# UNITED STATES PATENT AND TRADEMARK OFFICE

APPLICATION NO.	FILING DATE	FIRST NAMED INVENTOR	ATTORNEY DOCKET NO.	CONFIRMATION NO.
09/590,586	06/08/2000	William W. Holmes IV	U6220/53569/NWJ-gasket	1012

**Office Action Summary**

## **DETAILED ACTION**

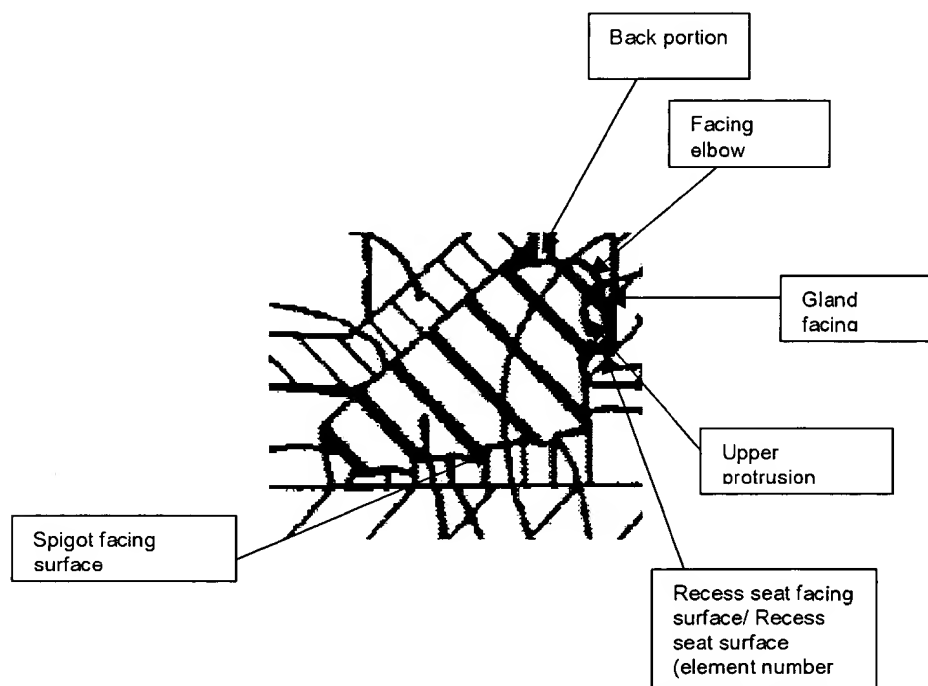
Re: claims 2, 3, 11, and 16. Harper shows in figure 1 a pipe joint comprising a male first pipe portion 4, a female second pipe portion 2, a compression gland 6 having a lip 8 located at an inner diameter of the gland disposed at least partially within the second pipe portion, and a restraining gasket shown in the area of element number 10 within in the second pipe portion and between the first pipe portion and the second pipe portion, the gasket further comprising: a compressible body having a spigot-facing surface, a recess seat-facing surface and a gland-facing surface, and a locking member

10, the member having a tooth arranged in between two inwardly extending ridges 29 discussed in col. 4 lines 56-57 and a back portion at least partially embedded within the compressible body wherein at least a portion of the tooth is positioned to engage the first pipe portion wherein the locking member is adapted to pivot as shown in figures 3a and 3b in response to a force tending to separate the first pipe portion from the second pipe portion, and wherein the locking member is adapted to resist movement between the first pipe portion and the compression gland in the event of such force.

Re: claims 4-10. The various claimed areas of the locking member are shown as labeled by Examiner above.

Re: claim 13. Harper shows in figure 1 a gasket interchangeable with gaskets of standard mechanical pipe joints for securing the ends of intersected assembled pipe portions, the gasket comprising a compressible body adapted to encircle a spigot end of a first pipe length 4 and adapted to fit within a bell end of a second pipe length 2, the

gasket having a spigot facing surface, and a recess seat surface as labeled above, the compressible body having embedded therein a locking member 10 having a toothed edge shown in the area of the spigot facing surface, a gland meeting area shown in the area of the gland facing surface, and a recess seat meeting area shown in the area of the recess seat surface, the toothed edge disposed in proximity to the gland facing surface and the recess seat meeting area disposed in proximity to the recess seat surface.

Re: claims 14 and 15. Harper shows the gland facing surface or the recess-seat meeting area comprising a tooth shown in the area of the labeled upper protrusion.
